<b>Subject:</b> <b>WHITE OR BLUE SMOKE FROM TAIL PIPE AFTER LONG IDLE PERIOD</b>	<b>Bulletin No:</b> 01-002/11
	<b>Last Issued:</b> 04/21/2011

- This bulletin supersedes the previous bulletins 01-004/10 issued on 01/07/10, 02/17/10 and 08/18/10 and 01-002/11 issued 01/12/11 and 02/23/11. The INSPECTION PROCEDURE, REPAIR PROCEDURE, PART(S) INFORMATION and WARRANTY INFORMATION have been revised.
- For 2006-2007 Mazdaspeed6 vehicles with this concern, refer to TSB 01-001/11 ("WHITE OR BLUE SMOKE FROM TAIL PIPE AFTER LONG IDLE PERIOD").

### VENTILATION SET REMOVAL:

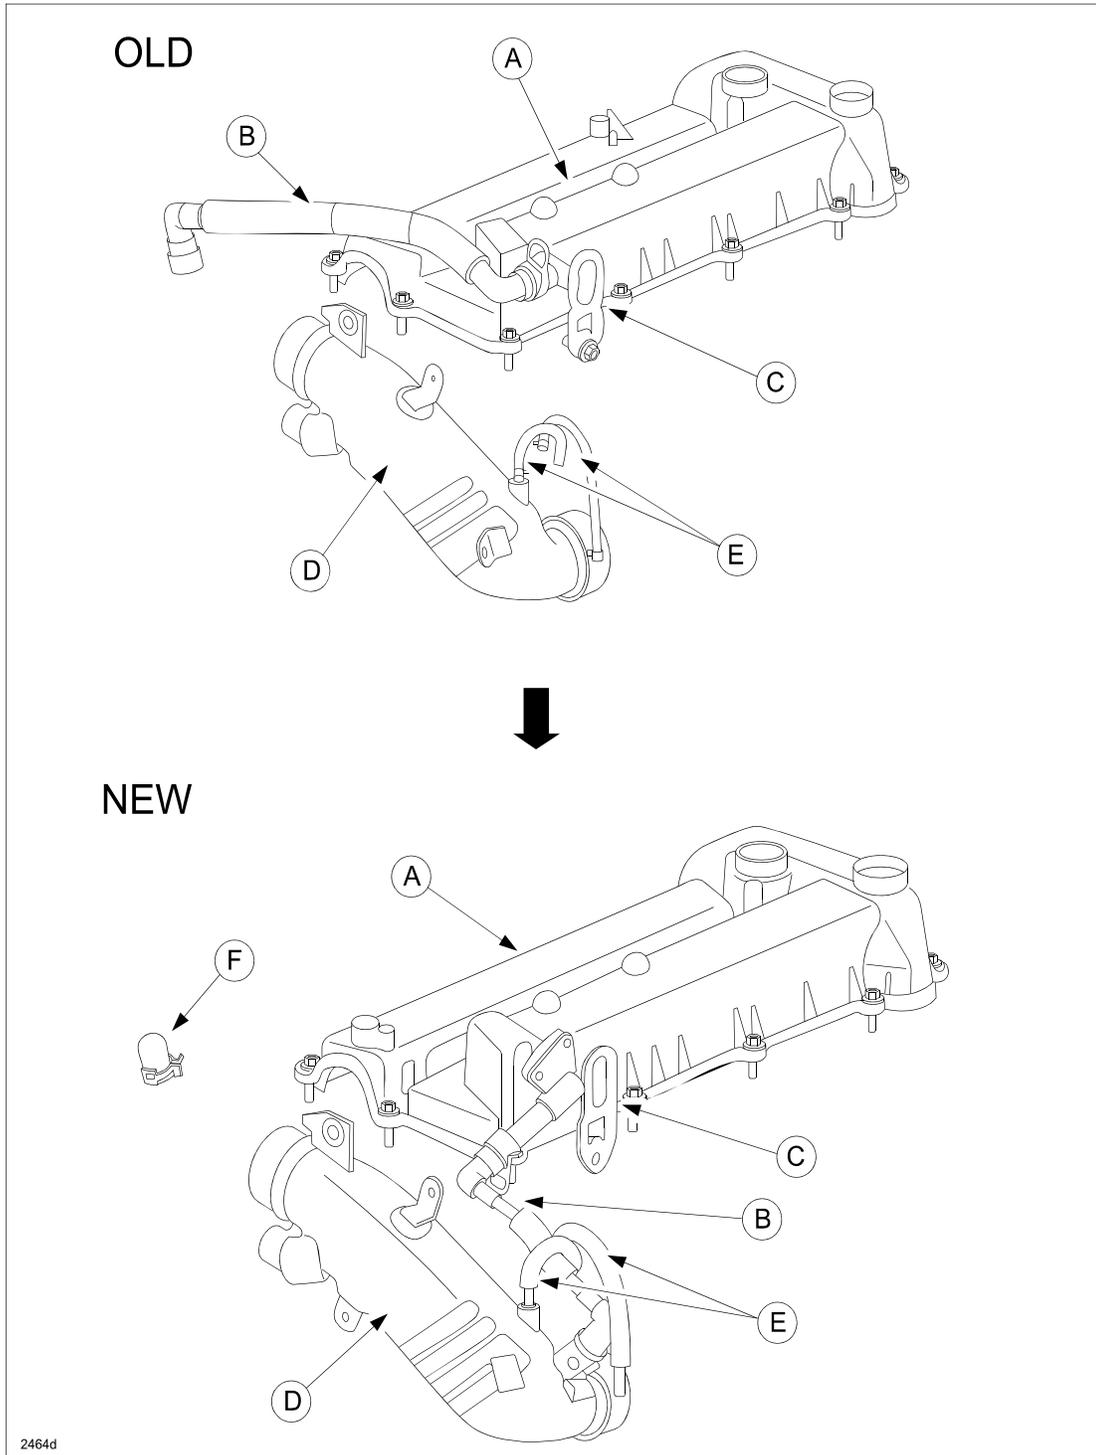
Replace the cylinder head cover (A), ventilation hose (B), engine hanger (C), air pipe (D), vacuum hose (E) and plug (F) (all components included in the Ventilation Set).
